**Final Rule**

LSA Document #19-330(F)

**Rule 4.4. 2020 Indiana Residential Code**

(b) This rule shall be known as the 2020 Indiana Residential Code.

**FIGURE R502.8  
CUTTING, NOTCHING, AND DRILLING**

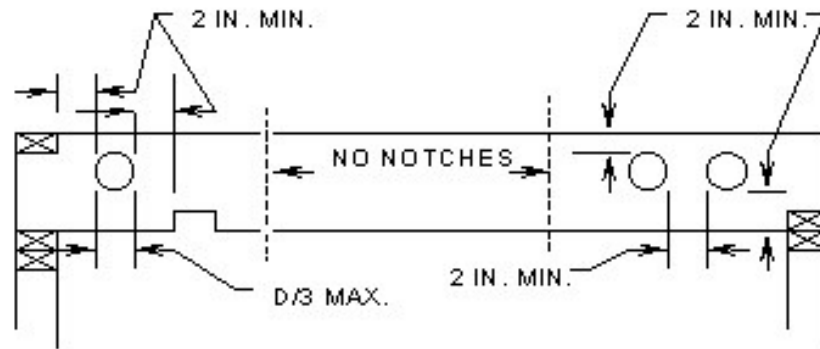
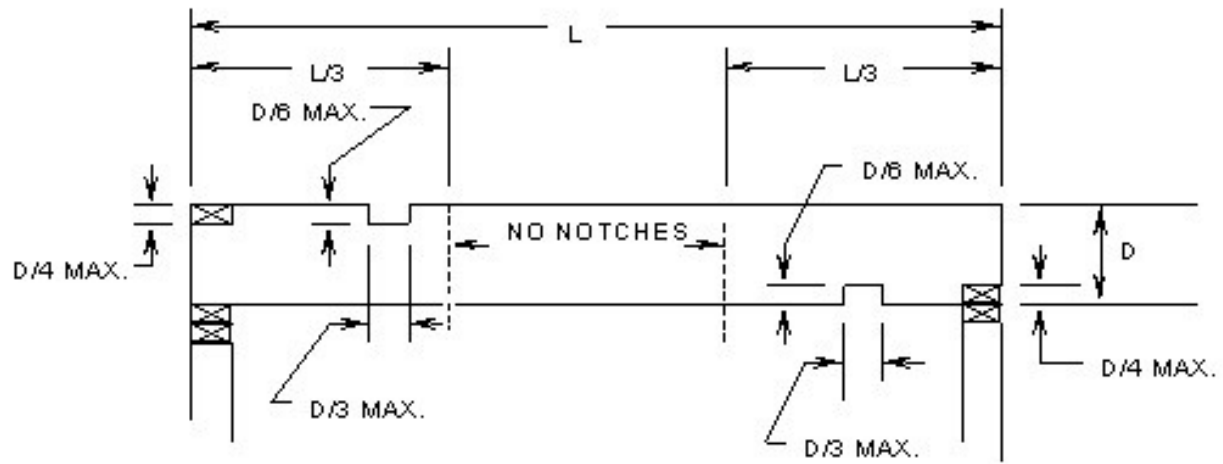
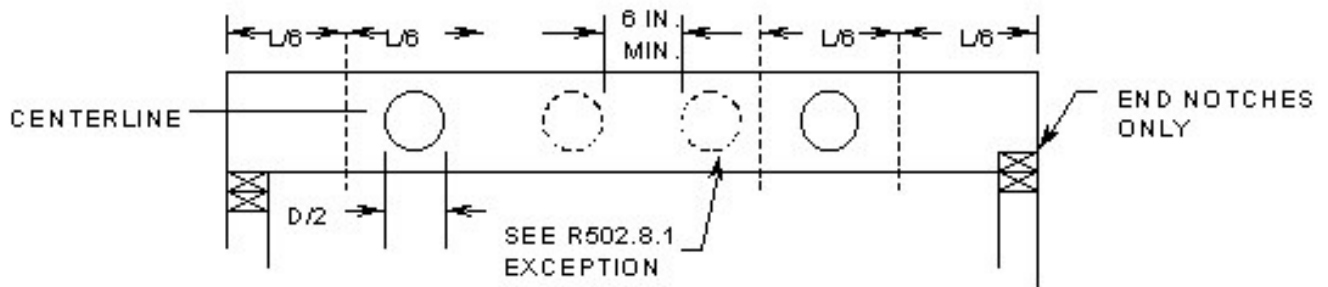
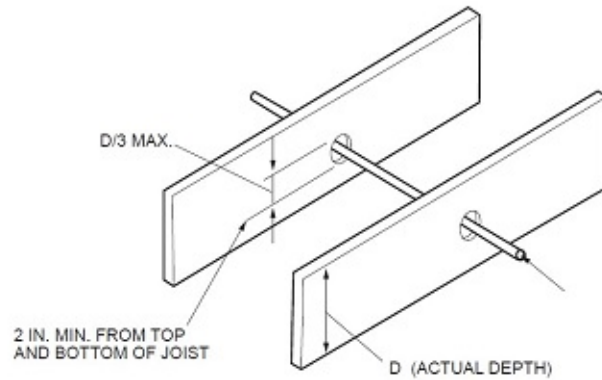
**Sec. 59. Delete FIGURE R502.8 and substitute to read as follows: FIGURE R502.8:**

**FIGURE R703.7.6(1)**

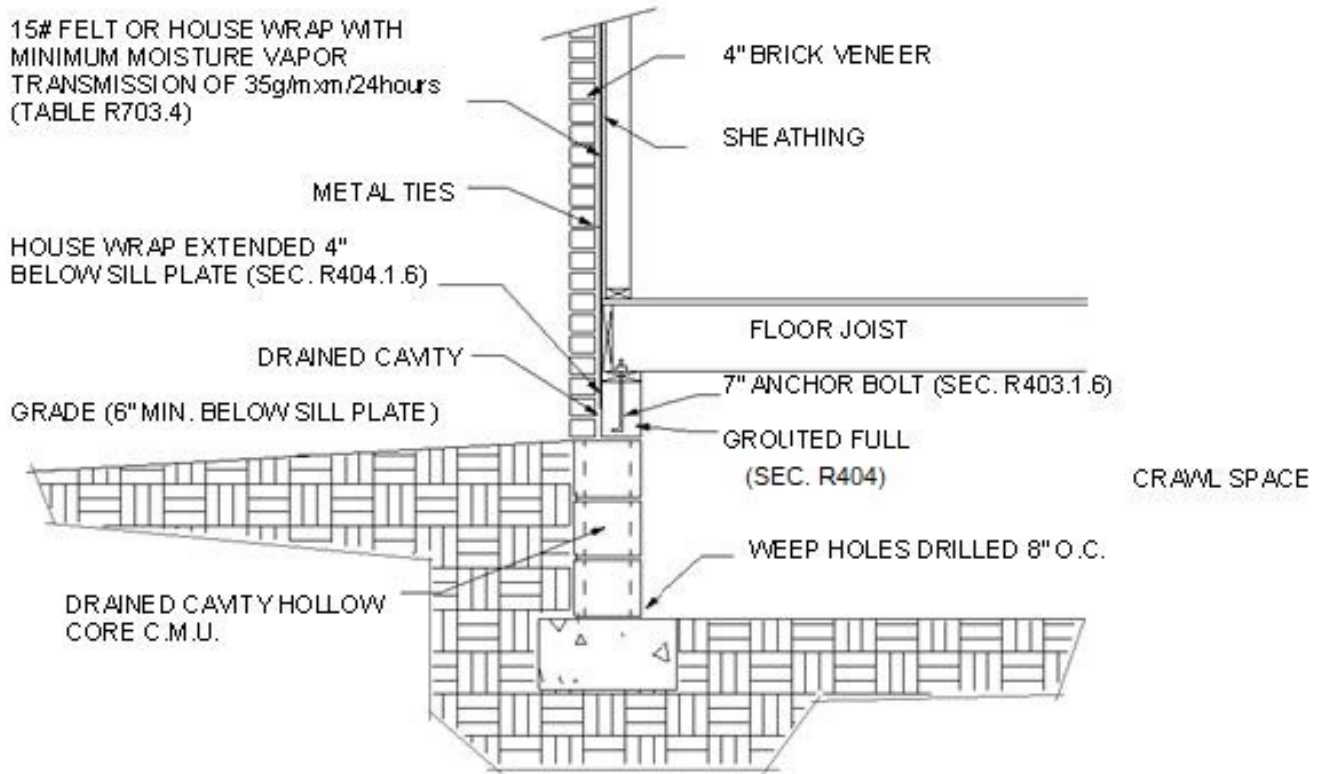
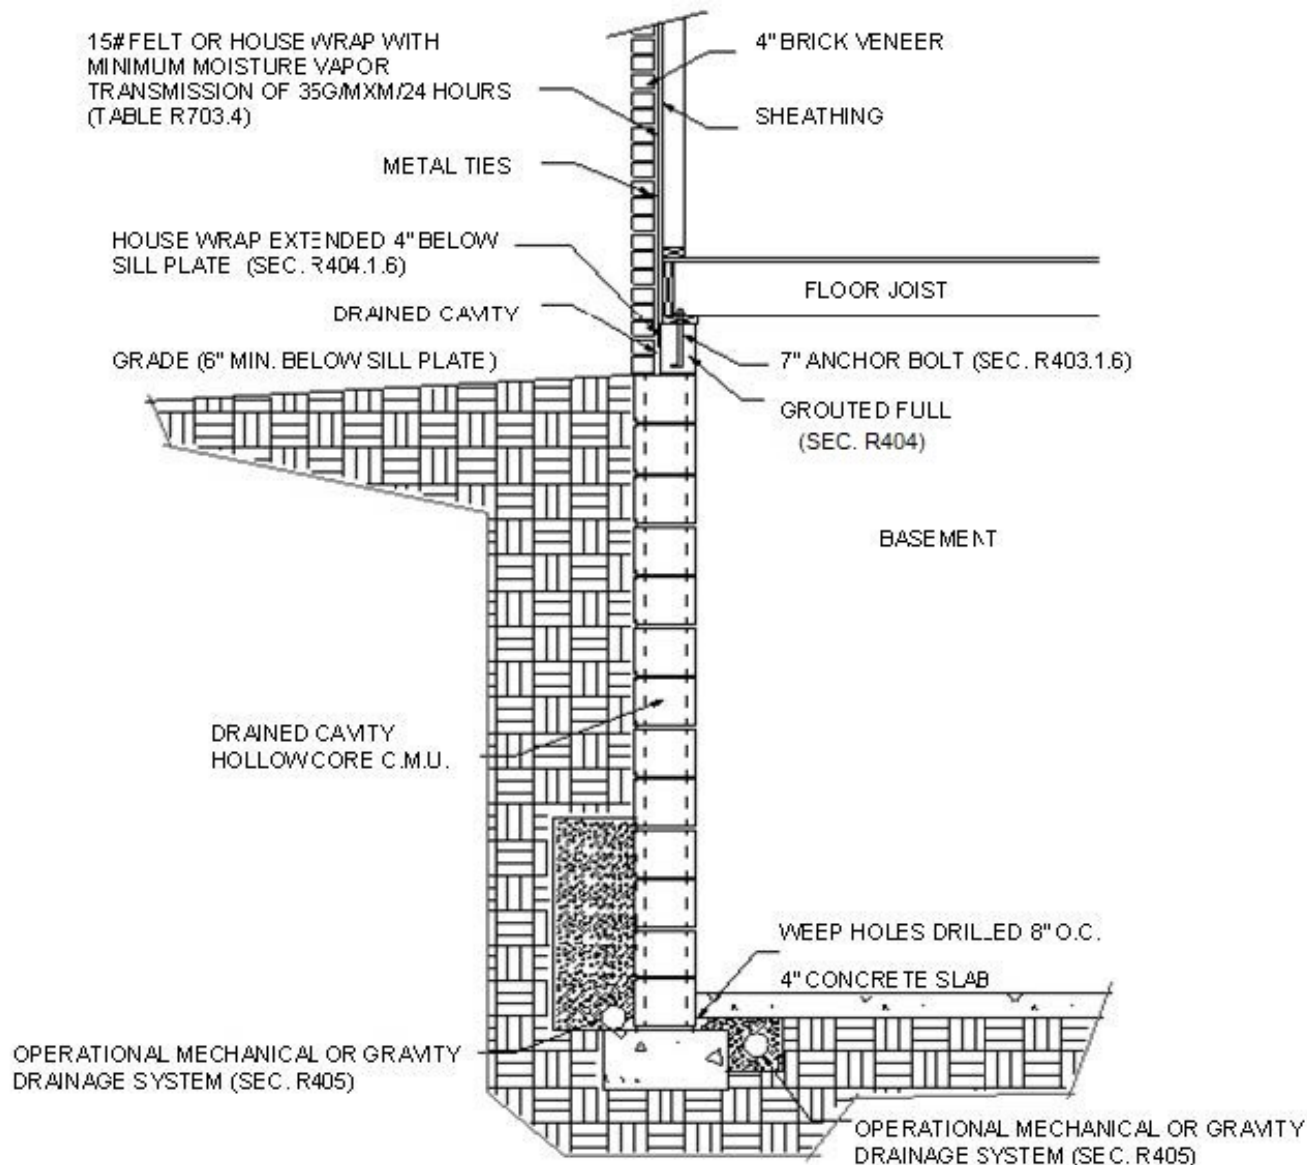
Sec. 79. Delete SECTION R703.8.6 in its entirety and substitute to read as follows:

The 3/4 inch (19 mm) air cavity shall be drained to the exterior of the structure at intervals of not more than 33 inches (838 mm) on center. Each drain shall be not less than 3/16 inch (4.8 mm) in diameter, located immediately above the flashing. For dwellings with crawlspaces, the air cavity may be drained as shown in FIGURE R703.8.6(1). For dwellings with basements, the air cavity may be drained as shown in FIGURE R703.8.6(2).

**FIGURE R1003.9 TERMINATION**

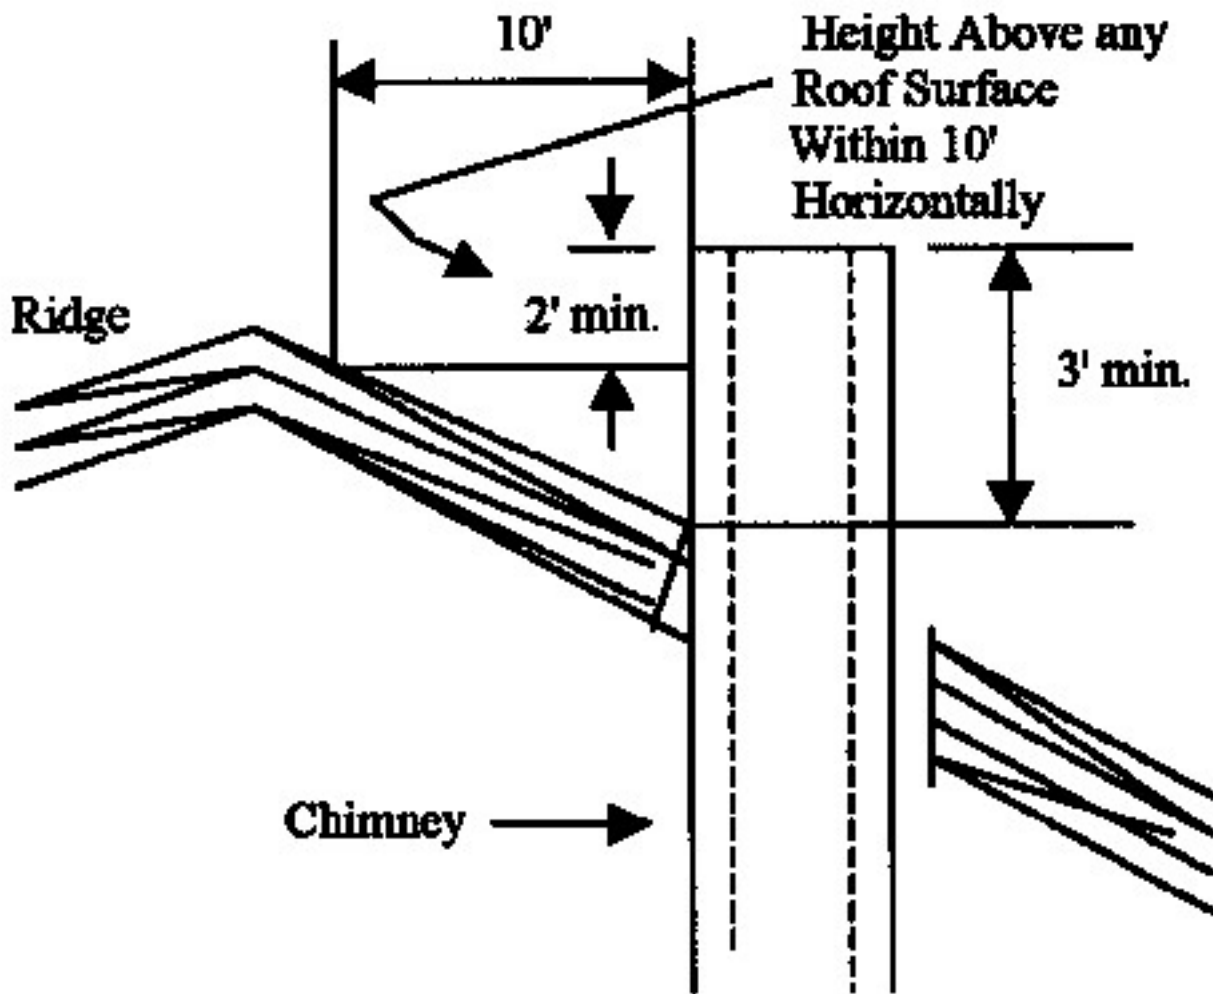
Sec. 88. Add FIGURE R1003.9 after SECTION R1003.9 as follows:
